1989 - 1991 Corvette: Service Bulletin: No/Delayed Reverse When Cold

Subject: NO/DELAYED REVERSE WHEN COLD INSTALL REV.
INPUT CLUTCH SEAL

Bulletin Number: 91-493-7A - (03/11/1992)

1989-91 HYDRA-MATIC 4L60 (MD8)

Figure 1

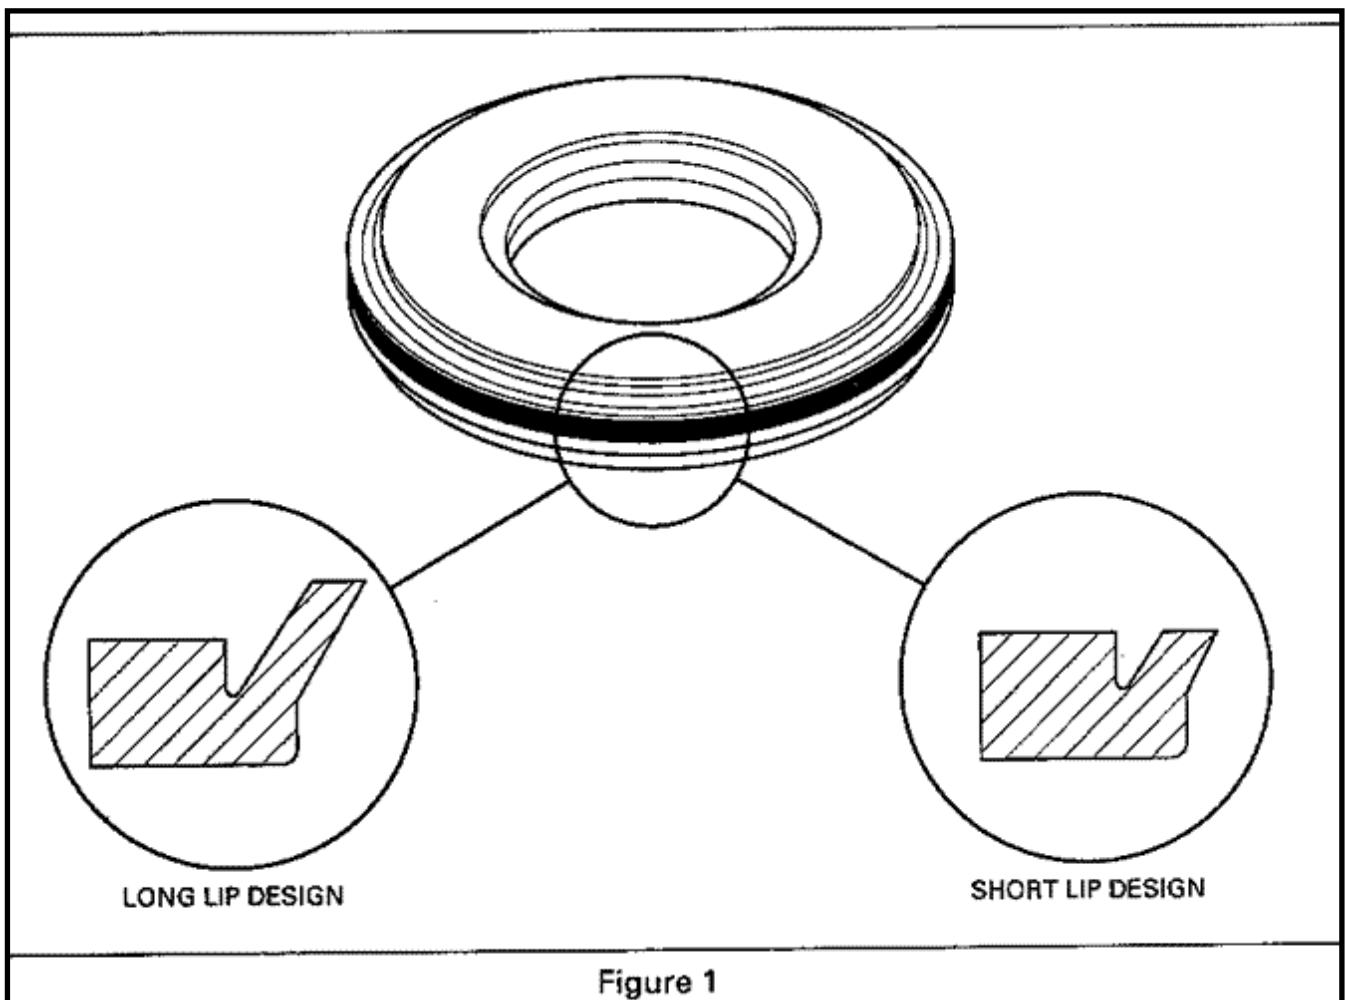
If a transmission has a 'no reverse' or 'delayed reverse' condition, inspect the reverse input clutch piston outer seal. Determine if the seal is a 'short lip' or 'long lip' design by comparing it to Figure 1. If it is a short lip design, replace it with a long lip seal contained in the service packages listed under Service Parts Information.

If the reverse input clutch piston outer seal is a long lip design, or the newly installed long lip seal doesn't alleviate the delayed reverse condition, the reverse input clutch housing may be out of round. Inspect the housing and replace if necessary.
